MEMORANDUM

SUBJECT: Minor Heritage Permit Application
145 John Street, Thornhill
Front Yard Landscape Alterations

Property/Building Description: Two-storey dwelling with attached garage constructed in 1969 as per MPAC records.

The front yard of the subject property as it appeared in November 2021 prior to the recent alterations (Source: Google)

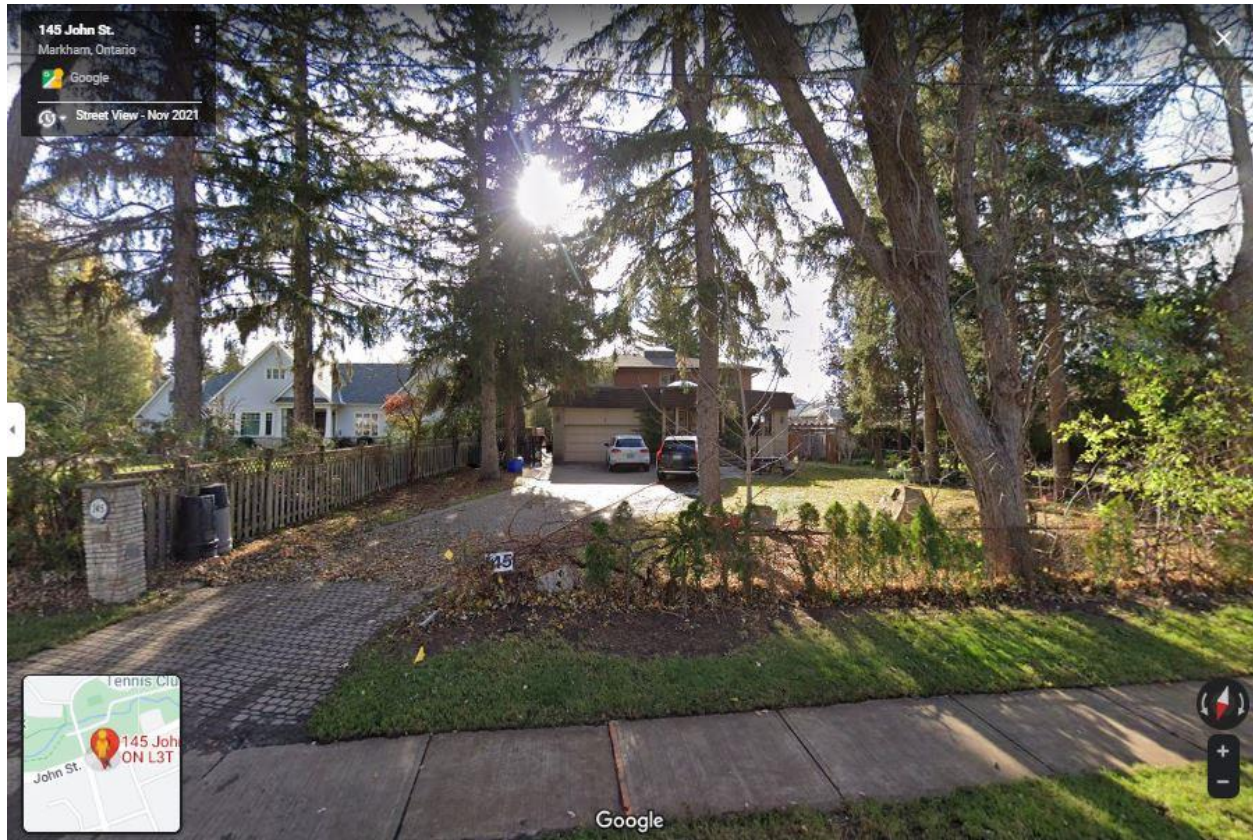
- While Heritage Section staff have no objection to the chosen pavers for the driveway, the installation of driveway gate posts and the paving of the front and side yards are not supported;
- Heritage Markham did support a Minor Heritage Permit application for a driveway gate at 146 John Street as it extended the existing white picket treatment across the driveway. Notwithstanding guidance in the THCD Plan prohibiting the installation of driveway gates, Heritage Section staff did not consider the proposal to be visually obtrusive or

- Staff do note that a landscape buffer has been retained between the newly hard-surfaced front yard and the John Street right-of-way.
- Staff could support the creation of a walkway leading from the driveway to the front entrance of the house in a paving material different from what has been installed for the driveway, but the current extent of paved surface is not in keeping with the landscape character of the Thornhill HCD which is typified by mature plantings and lawn. As such, it is in the opinion of Staff that the alterations do not comply with the policies and guidelines of the District Plan.

THAT Heritage Markham does not support the front yard landscape alterations and masonry gate posts and recommends that the Minor Heritage Permit Application seeking approval of the unauthorized alterations be denied, and that the interlock pavers be removed from the former sodded areas.
